Addendum No.: 2

York Correctional Institution Central Plant and Piping Distribution

BI – JA – 465

The following clarifications are applicable to drawings and specifications for the project referenced above.

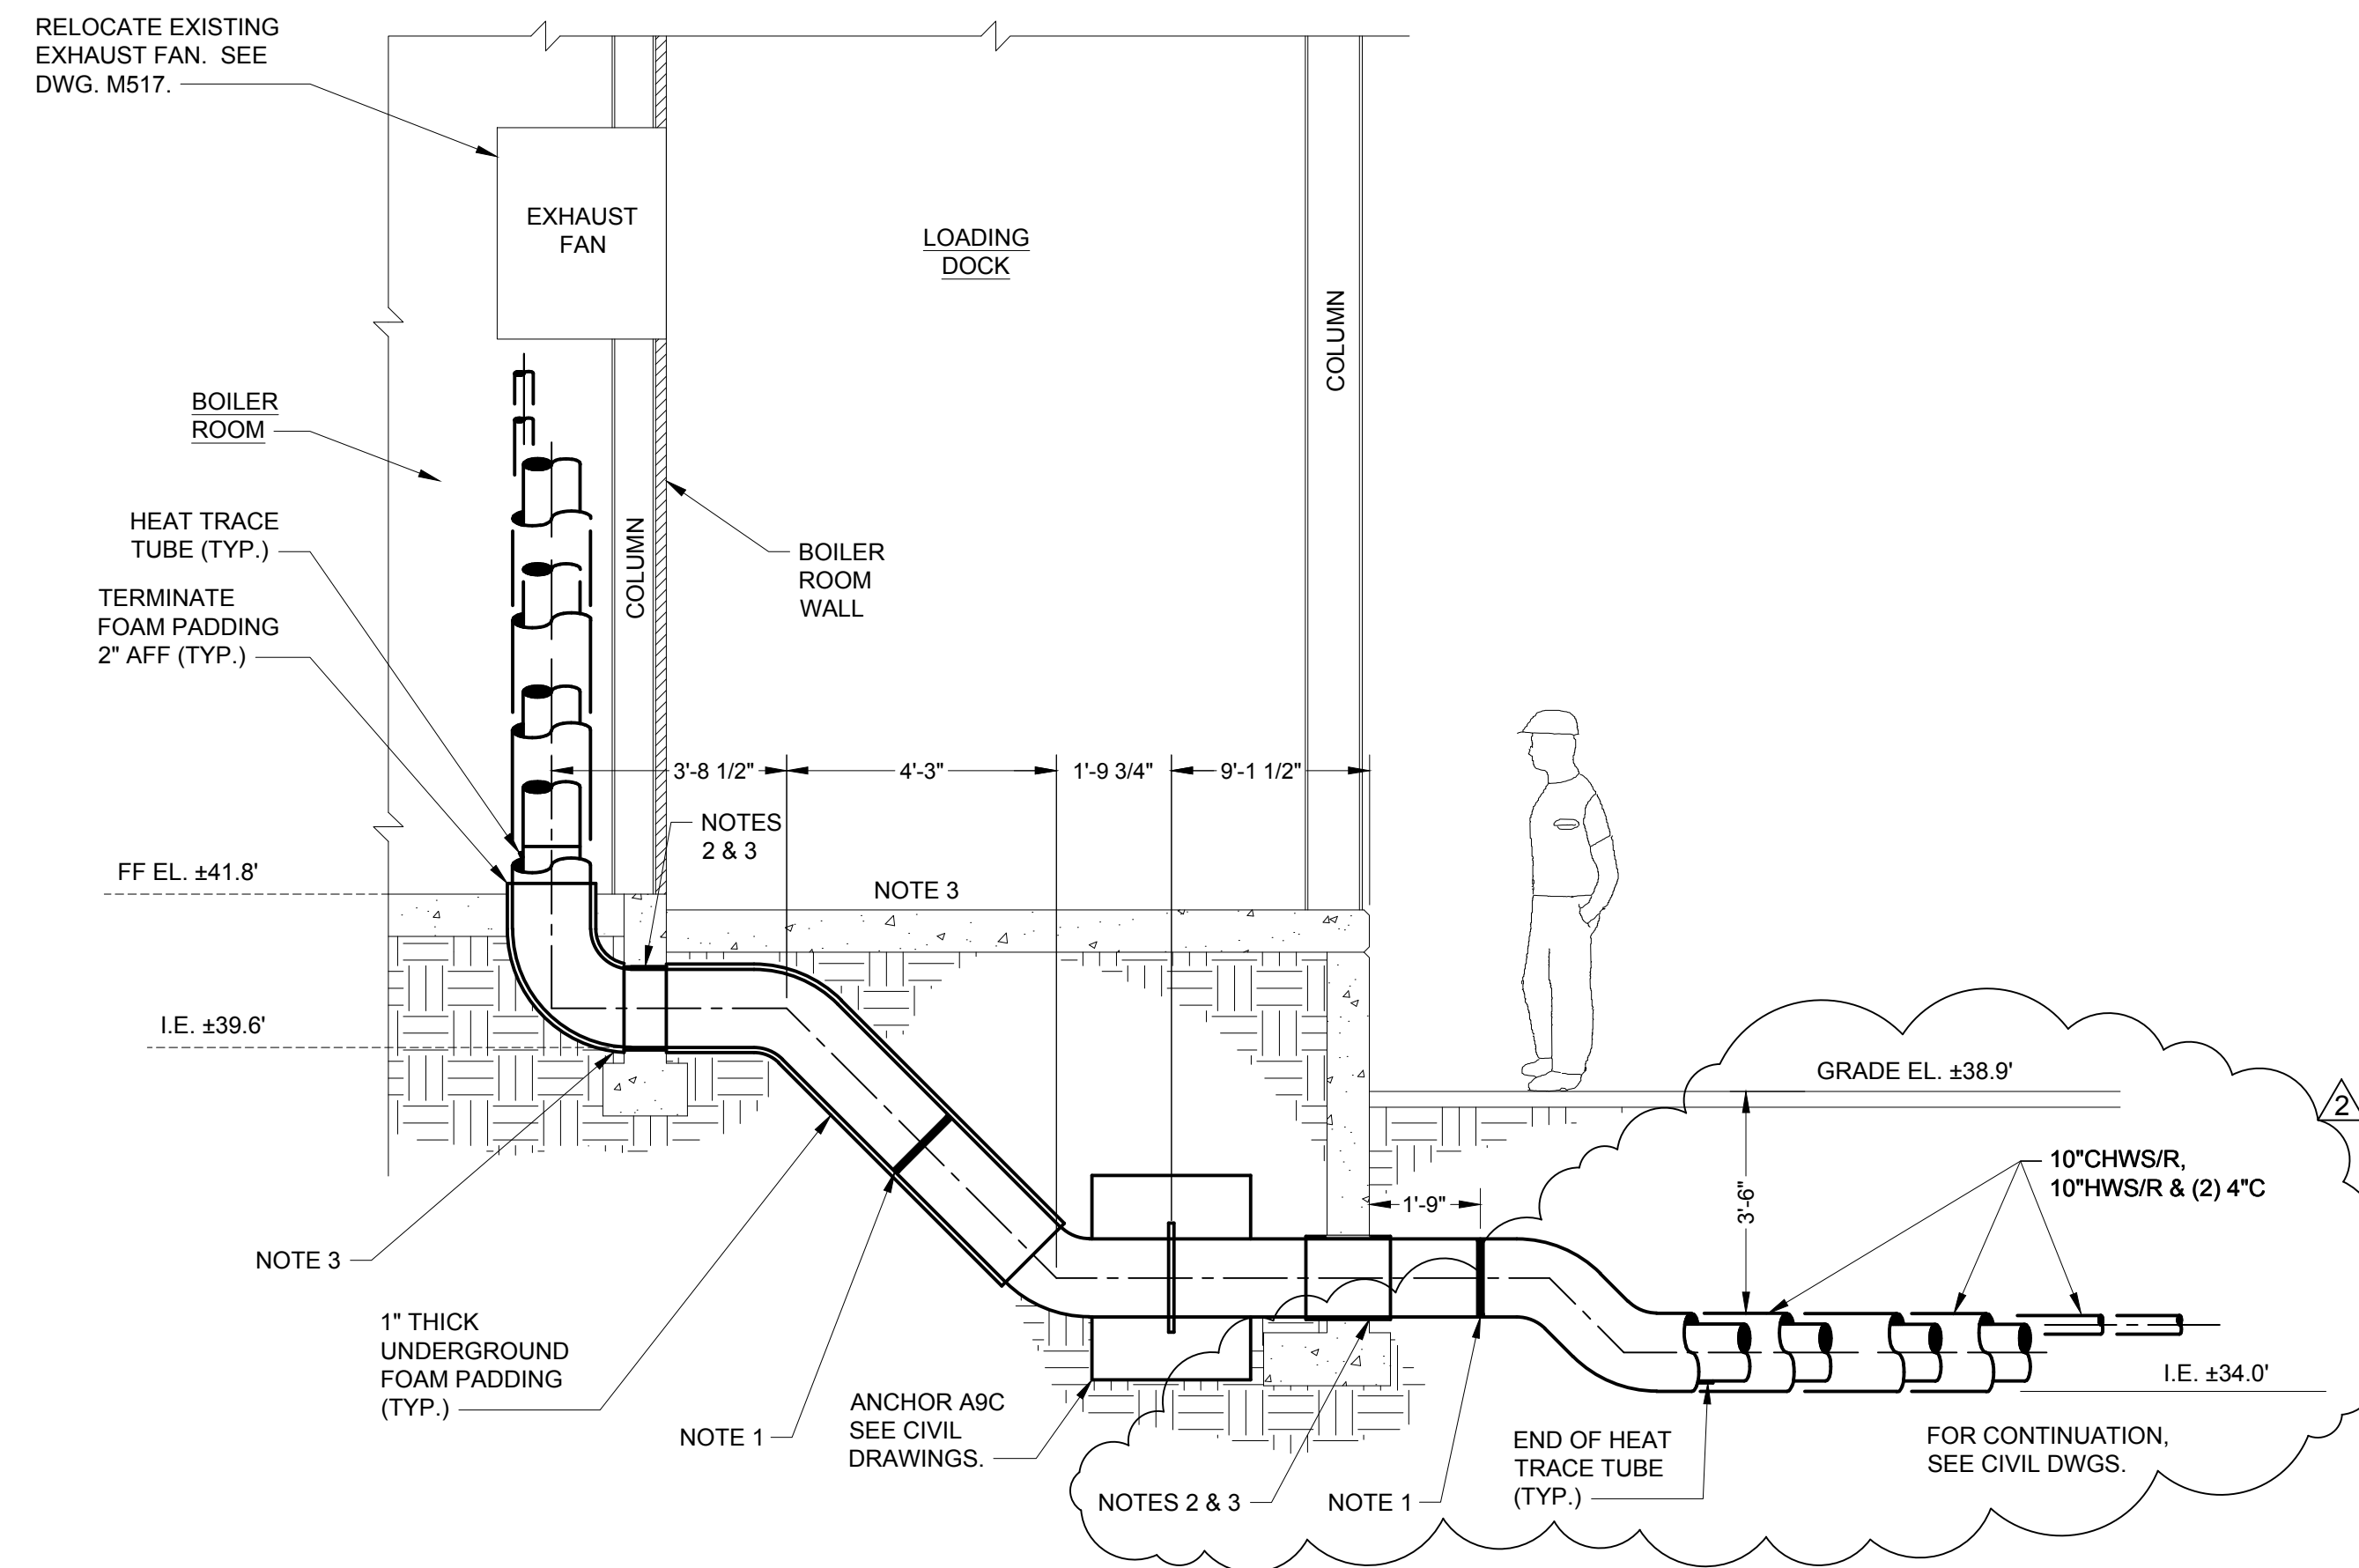
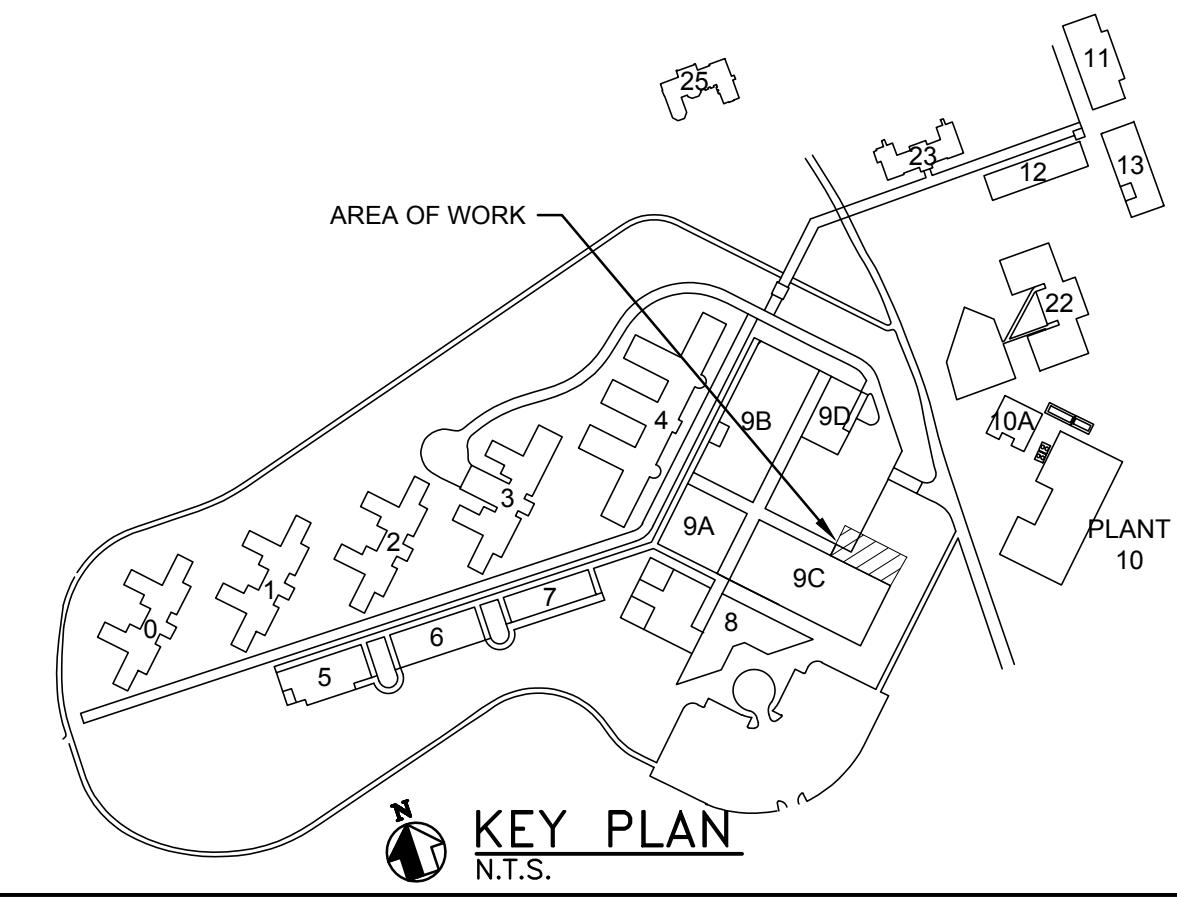
Drawing M518 Building 9C Boiler Room Installation Section

REPLACE the entire drawing with the attached.

UPDATED section to show second underground piping offset.

- ***Q1: (23A/26A) On Addendum #1 Drawing M518, the grade elevation where the image of a person is 38.9' and the bottom of the trench is 35.34', which would make that approximately 3'-7" deep to the bottom of pipe. The 10" pipe with insulation is about 14" diameter, that would be approximately 28" of cover, and on Addendum #1 Drawing C502 Detail #6 indicates 42" min. cover. Do we need to Heat Trace the entire runs of all the HW & CHW S&R lines or do we lower the grade at the bottom of the trench? Please advise.***

A1: The intent is to provide heat tracing for limited lengths of underground piping where 42" cover is not available and not to provide heat tracing for entire runs of underground distribution piping. The segments of underground distribution which have less than 42" cover are generally short sections of piping which are near the new "doghouses" at the buildings and in the Building 9C loading dock area. The existing Fuel Oil piping from the Central Plant wall to the above ground Fuel Oil storage tank also gets heat traced per Drawing M209.

2 BUILDING 4 TEMPORARY PIPING DEMOLITION
 SCALE: 1/32" = 1'-0"
 SCALE IN FEET

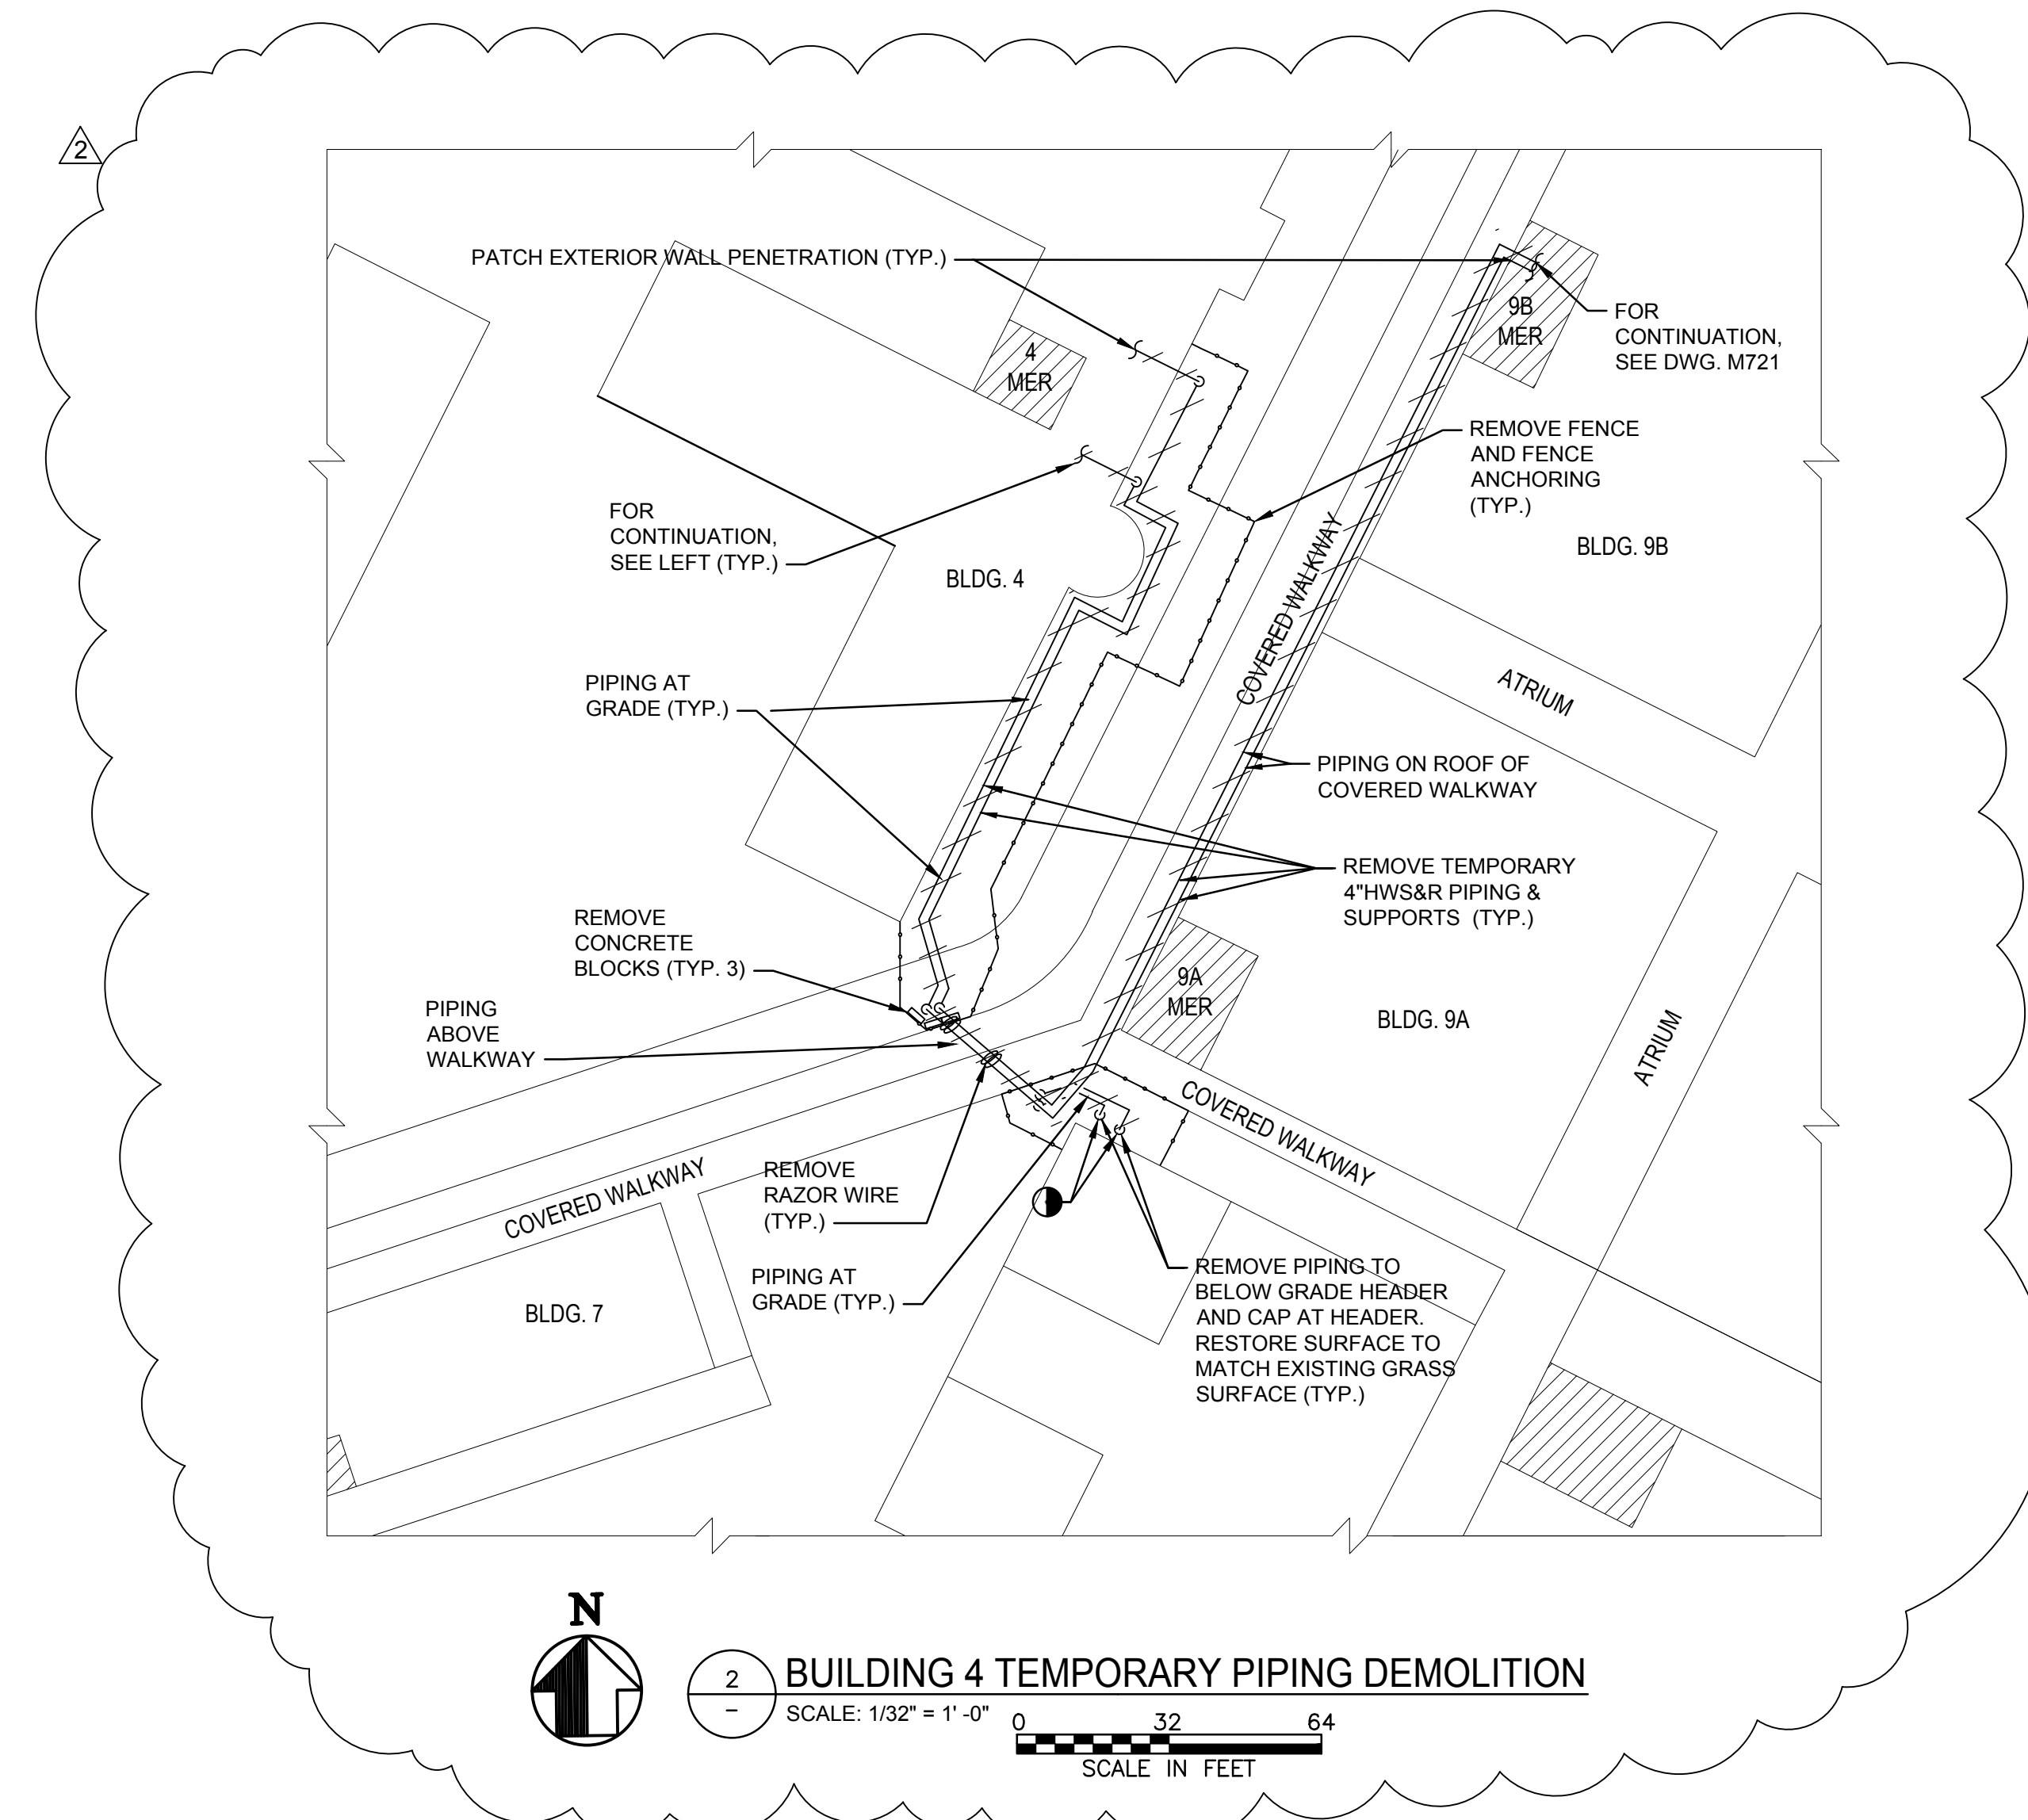
Drawing M709 Building 4 Part Plan Demolition

REPLACE the entire drawing with the attached.

ADDED part plan showing removal of temporary 4"HWS&R piping

D 5 ULTRASONIC FLOWMETER/ENERGY METER
NTS

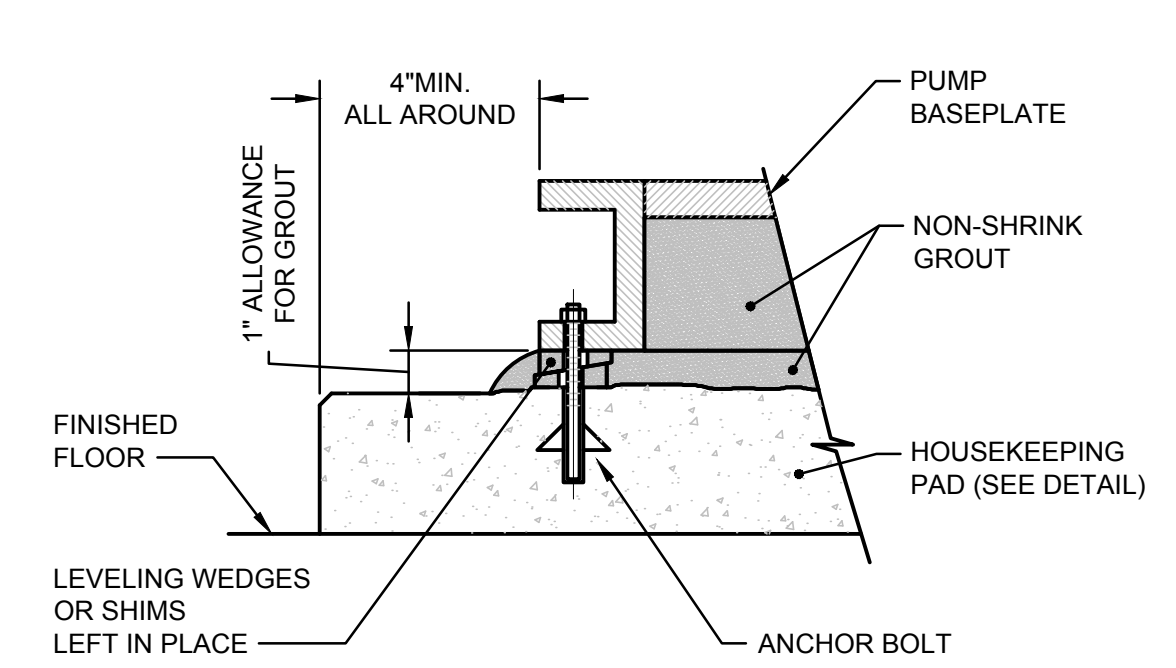
Drawing M905 Details - 6

REPLACE the entire drawing with the attached.

UPDATED detail 5 to include Energy Meter; updated detail 9 title for clarification
